AMENDMENTS TO THE DRAWINGS

REMARKS

F16.6

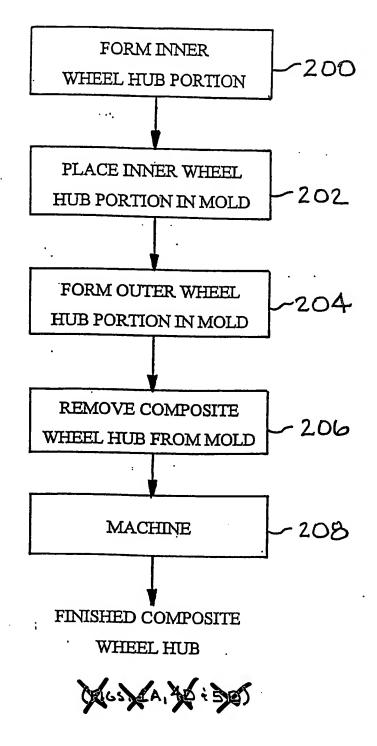
Please amend drawing Fig. 6 by deleting reference characters 1A, 4D and 5D at the bottom of Fig. 6 as shown in red on the attached sheet of drawings labeled "Annotated Marked-Up Drawings. Also, attached are drawings sheets labeled "Replacement Sheet" of Figs. 1-8.

In paragraph 3 of the Official Action, the Examiner has objected to the drawings for the reasons noted therein and has required corrected drawings in compliance with 37 C.F.R. 1.121(d). To comply with this request, attached hereto are new corrected drawings for this application. As discussed above, these drawings sheets of Figs. 1-8 are labeled "Replacement Sheets" and include the changes discussed above to Fig. 6.
